CITY OF CHELSEA, MA Department of Planning & Development

CASE: 2020-06 251 Arlington Street – RFR Development, Inc. 5/14/2020

REQUEST: Construction of a two-family dwelling, each unit with three bedrooms.

Re: DPW Review Comments Special Permit Application Case #2020-06 – 251 Arlington Street

Google Maps photos, September, 2019

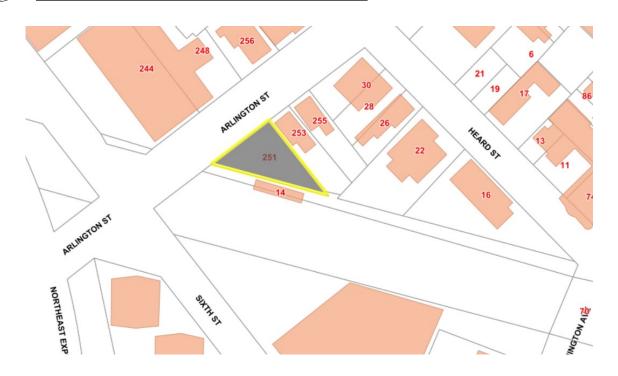
The second photo on the previous page shows a street tree in front of the proposed parking spaces. If the Board approves the Petition as proposed, the Petitioner should be required to address the loss of the street tree by providing funding to the Department of Public Works to replace the tree. This should be included in the landscaping plan required on the lot itself.
